Product Change Notification

Change Notification #: 114207 - 02

Change Title: Intel® Ethernet Converged Network Adapter X520-SR2 (Spring Fountain), MM #s: 900137, 901223, 927247,

PCN 114207-02, Product Design, Label, Product Marking, Product Material,

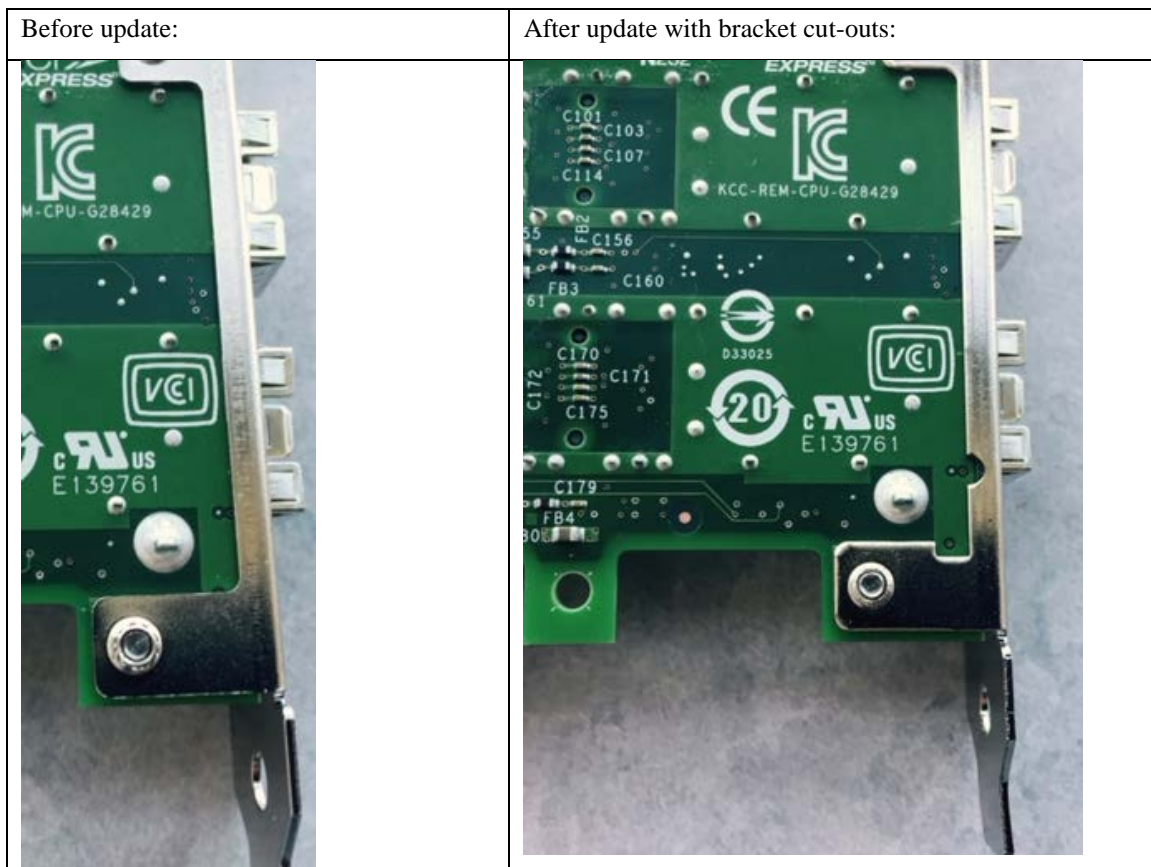
1. To improve the bracket clearance with via pads, the bracket has been re-designed with 2 notches. The part number on the Standard height bracket will change from E33052-003 to E33052-004. The part number on the Low Profile bracket will change from E33054-002 to E33054-003.
